October 21, 2022

Industrial Device Business Division,
Panasonic Industry Co., Ltd.

**Change notice: Change of screw diameter on motor connector housing
of MINAS A6 Series Servo Motors**

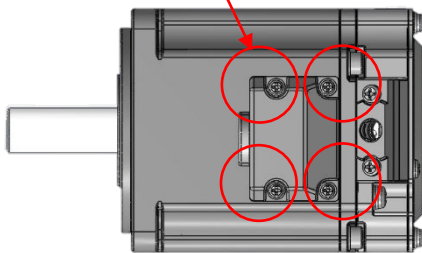
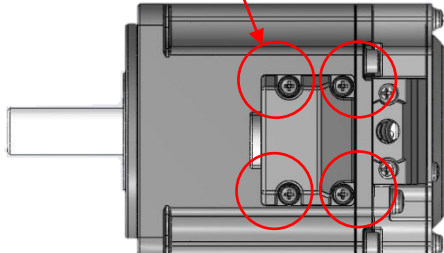
Before	After
Screw diameter	M2	M2.6
Description of the Change	<div>4-M2</div> 	<div>4-M2.6</div>

There will be no changes in characteristics, performance and dimensions of the Servo Motor due to the change in the screw diameter.
